GULF STATES UTILITIES COMPANY

November 5, 1984
RBG- 19,354
File Nos. G9.5, G9.19.2

River Bend Station - Unit 1
Docket No. 50-458

RESPONSES TO REQUESTS FOR INFORMATION
IN SECTIONS 2.2, 2.3, AND 2.4 OF ENCLOSURE 3
TO NRC DECEMBER 22, 1980 LETTER

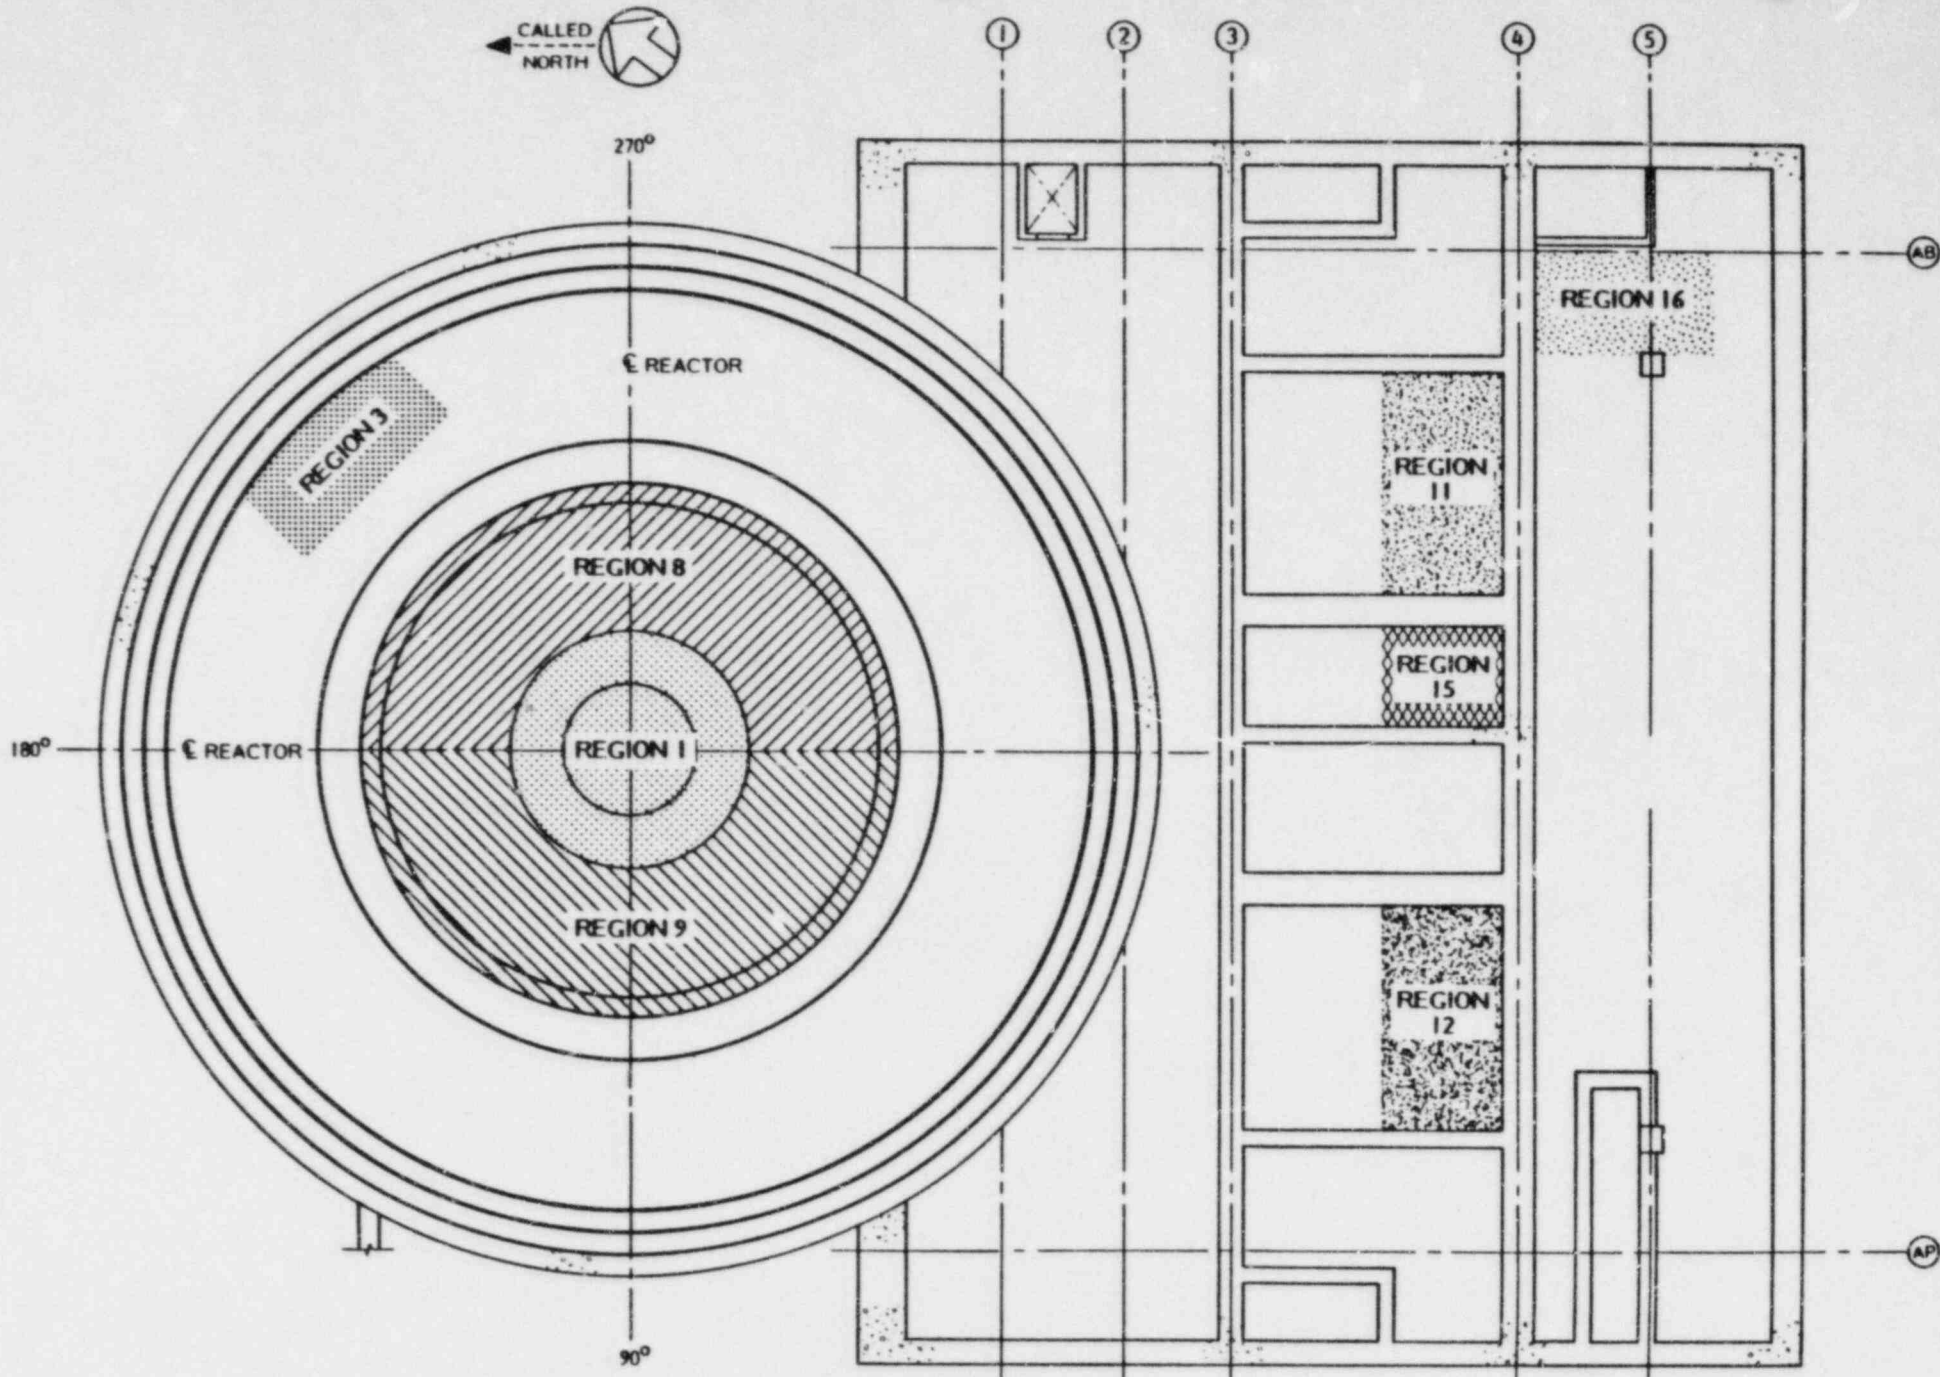
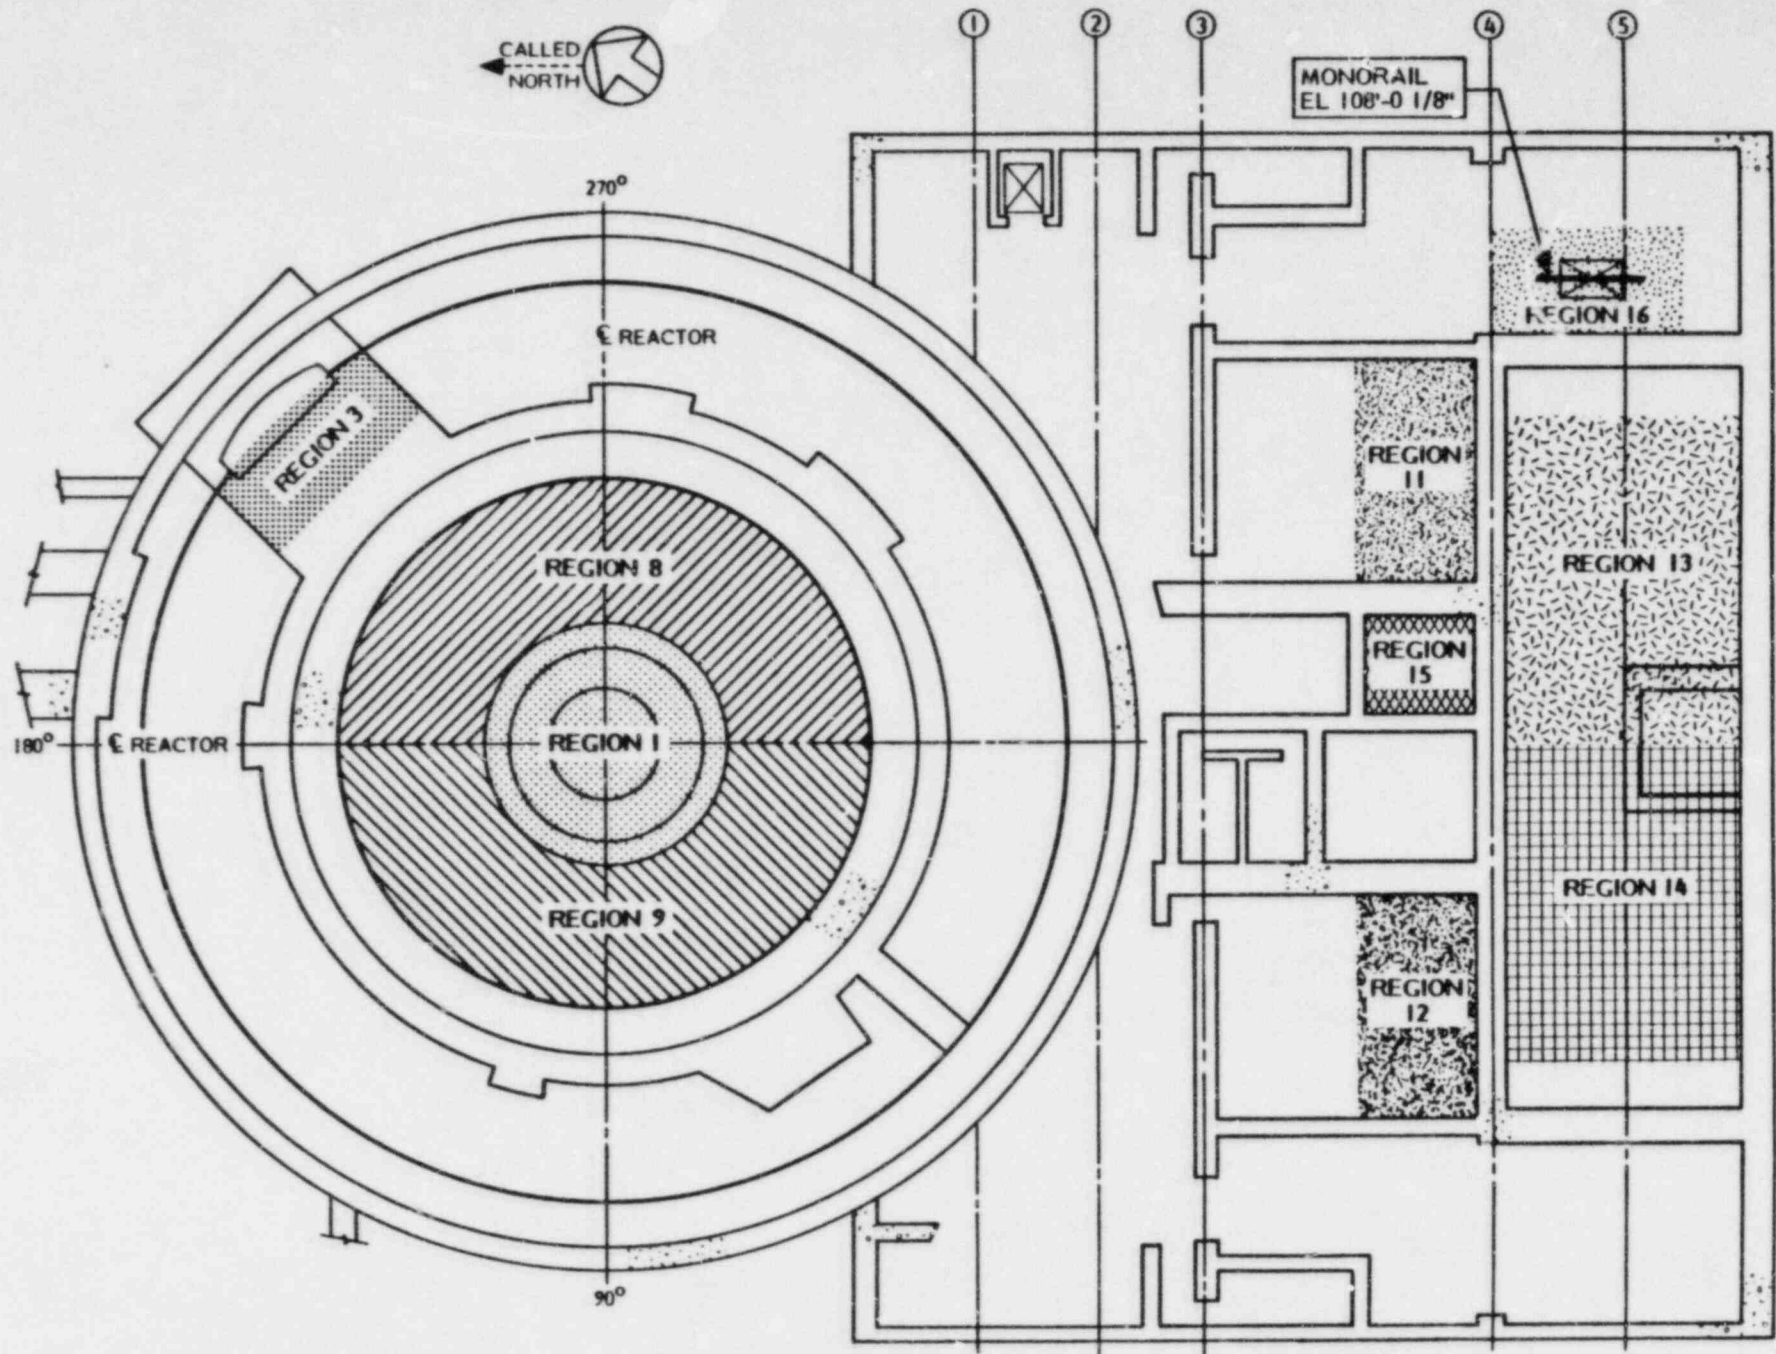
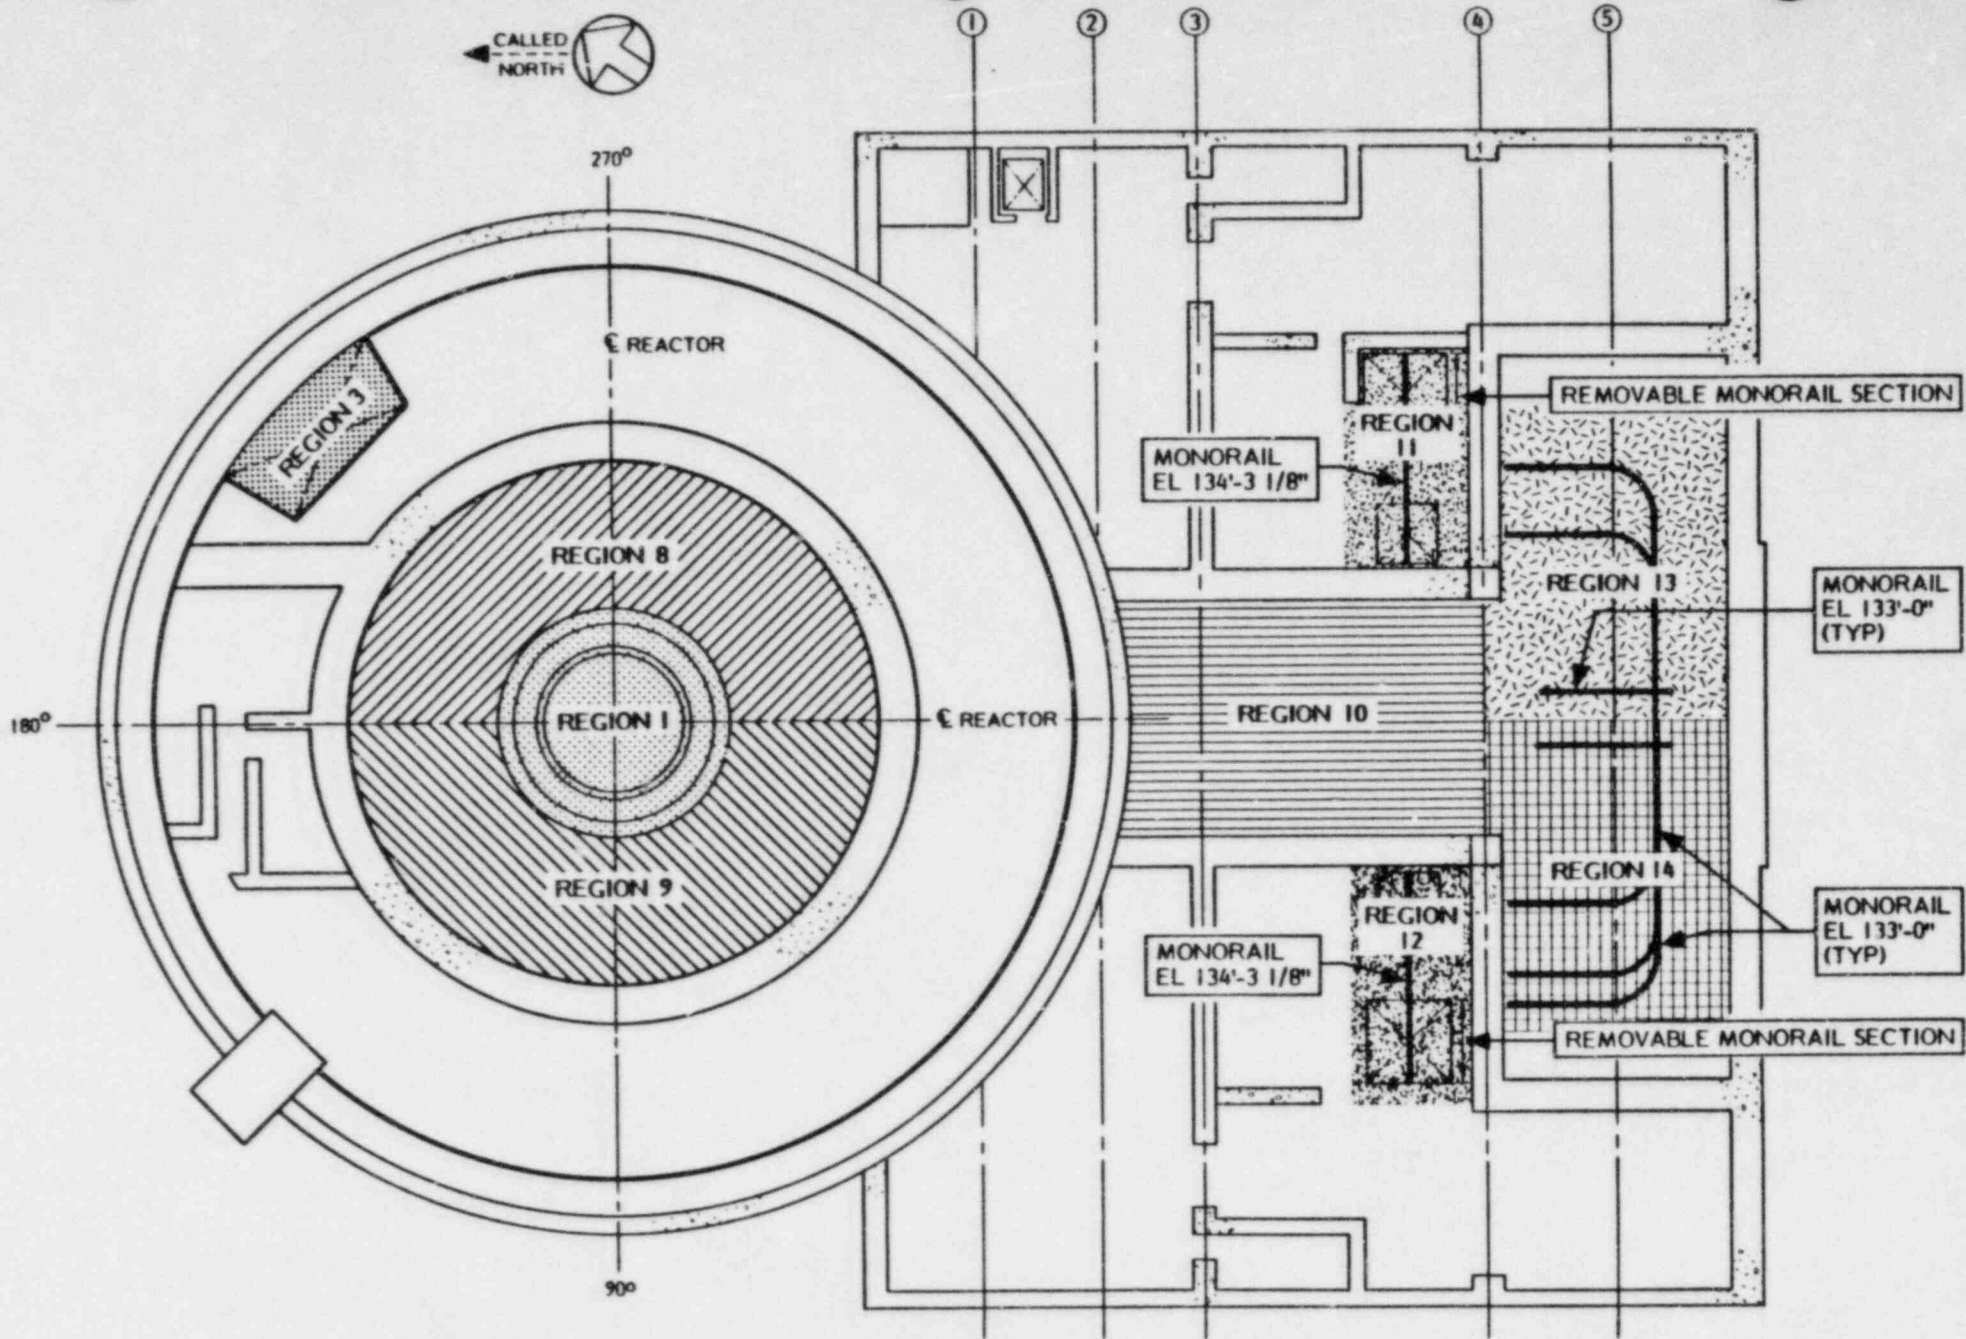
ITEM 2.4.2 For any cranes identified in 2.1-1 not designated as single-failure-proof in 2.4-1, a comprehensive hazard evaluation should be provided which includes the following information:

- a. The presentation in a matrix format of all heavy loads and potential impact areas where damage might occur to safety-related equipment. Heavy loads identification should include designation and weight or cross-reference to information provided in 2.1-3-c. Impact areas should be identified by construction zones and elevations or by some other method such that the impact area can be located on the plant general arrangement drawings. Figure 1 provides a typical matrix.

RESPONSE: Table I identifies the potential impact regions and the associated load handling systems. The loads corresponding to these handling systems were previously identified in response to item 2.1-3c. Figures I through II further describe the potential impact regions. For the handling systems identified in Table I (also listed in 2.4.1 above) a combination of systems and structural evaluations was utilized to determine if Criteria IV of NUREG-0612 is met for all postulated load drop scenarios. To assist these evaluations, a set of safety functions were identified corresponding to these criteria. The goal of these evaluations then became to demonstrate that the applicable safety functions could be accomplished for all load drop scenarios.
